## Avon Parks – Pickleball Park Addendum 03

DATE: Wednesday, February 25, 2026

PROJECT NAME: **Pickleball Park**

ATTACHMENTS: 012100 Allowance Specification, 047200 Cast Stone Masory, Door Hardware Information, Photos of Existing Gate, Sheet A1.6, Sheet S1-1

2 OVERHANG SECTION  
SCALE: 3/4" = 1'-0"

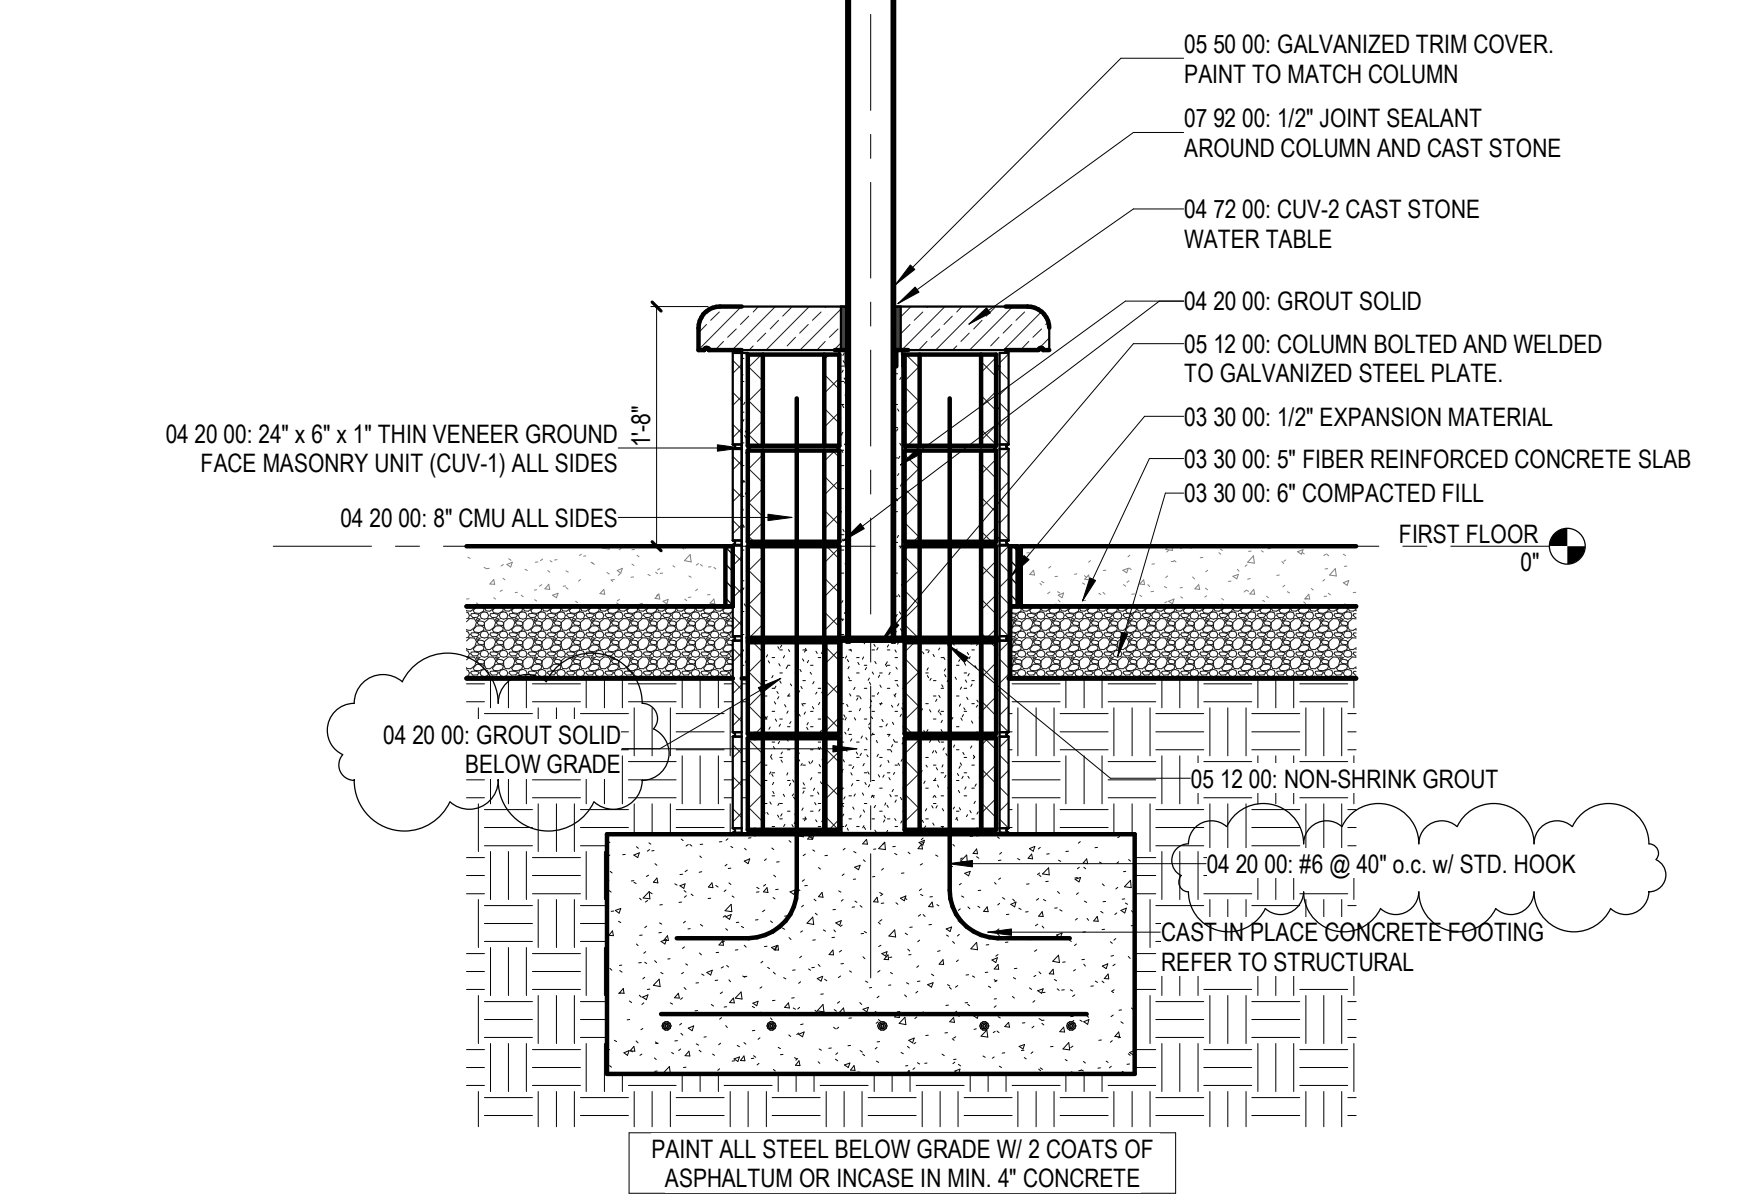
- 9) **Question:** What is the thickness of the stone for the seating shown in sheet A5-1 detail 3?  
**Response:** 3-5/8"
- 10) **Question:** Sheet A6-1 detail 2. Section 2. 05 50 00 Galvanized trim cover. This detail shows the column to be attached to the footer. But S1-1 detail 8. Steel col pair detail. This detail shows the columns, tubes attached to the top of the masonry. Please clarify which detail to be used?

- 12) Question:** Sheet A6-1, Detail 2-Section2 call note: Cast In place Concrete Footing refer to structural but there not detail in the structural. Please provide detail for reinforcement if any.

**Response:** Refer to drawing updates for clarity
- 11) **Question:** Sheet A6-1 Detail 1-Section. 07 46 46: 2x8 Trim Board. Please clarify if the intention is install a 1" x 2" x 8' all around or to install a 1" x 8" x 8'. There is not a 2"x8"x8' Trim.

- Response:** Refer to schedule on sheet S1-1 for required reinforcement.
- 13) Question:** Does this need an AISC inspection?
- Response:** AISC Requirement can be waived but standards will need to comply. No need for third party inspector as add alternate at this time.

1 C5.8 SECTION  
SCALE: 3/4" = 1'-0"

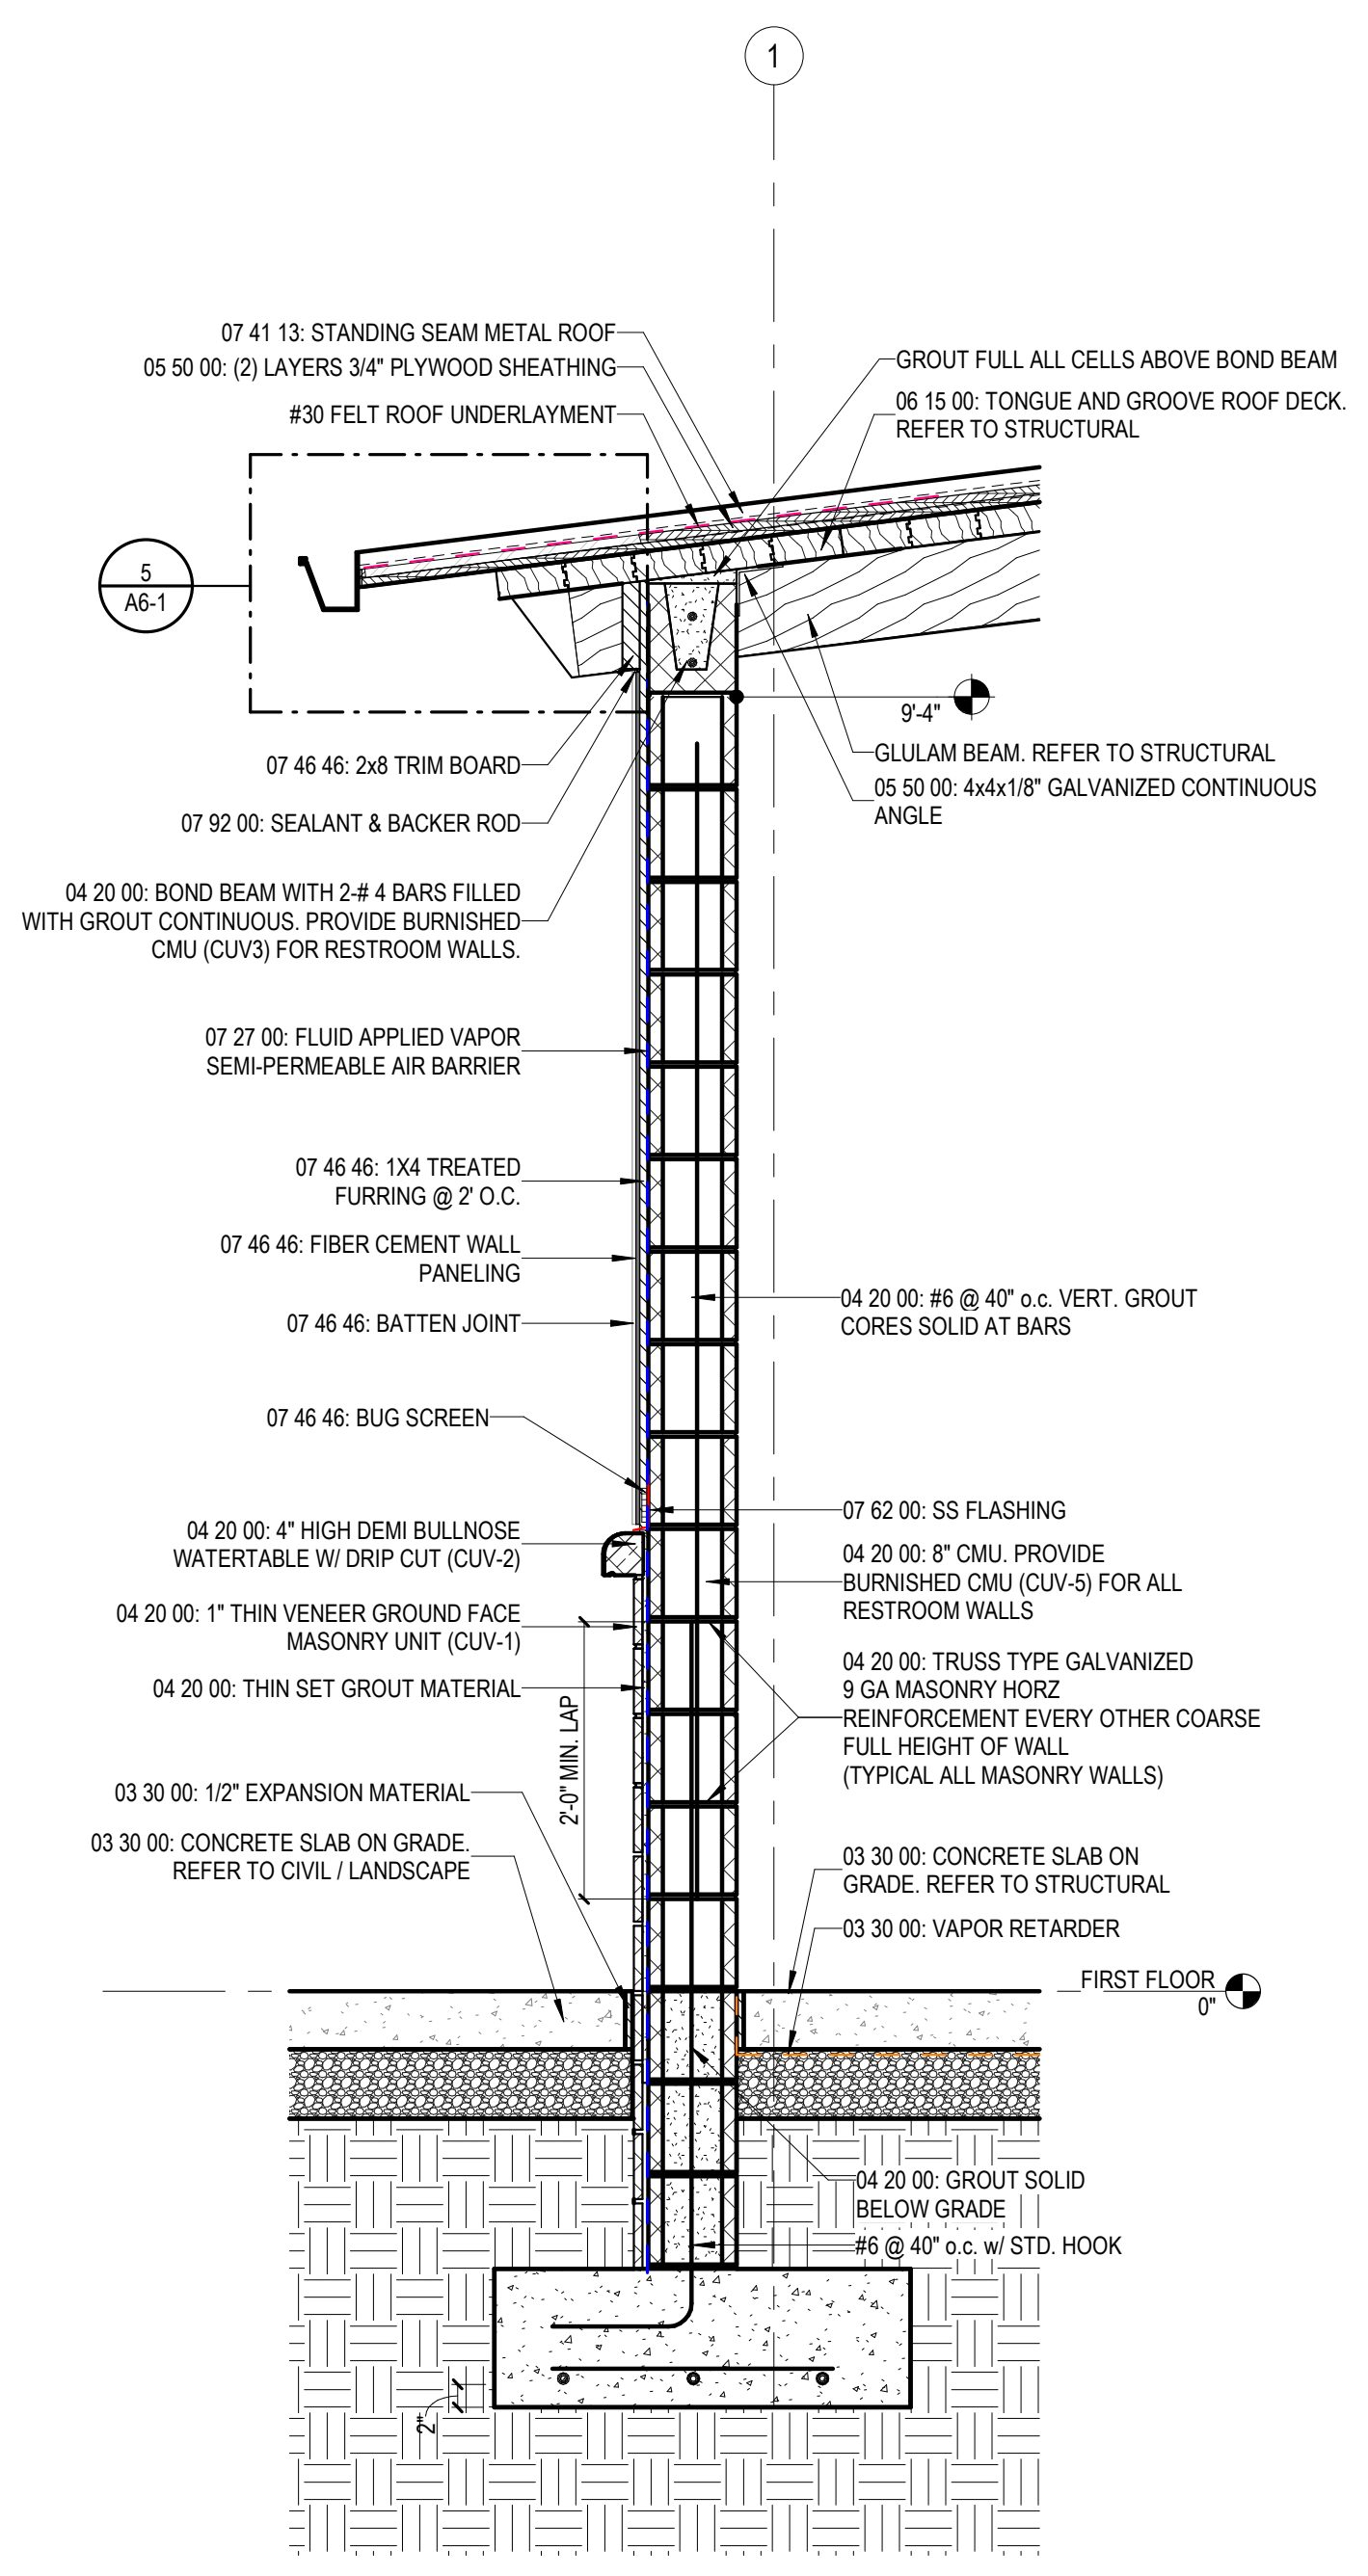
**Response:** Yes.
- 8) **Question:** On A6-1/1 – C5.8 Section, you call for the same 4" bullnose that is called for in detail 2. However, in detail 2, it is sitting on top of 8" CMU. In detail 1, it is sitting on top of 1" thin brick. This brick will not support a bullnose of that size. Could you please clarify the size of bullnose you would like used in Detail 1?

**Response:** On A6-1/1 Provide thin stone support angle. Work with manufacturers to provide size that is compatible with thin stone applications and get shape that is close to drawn
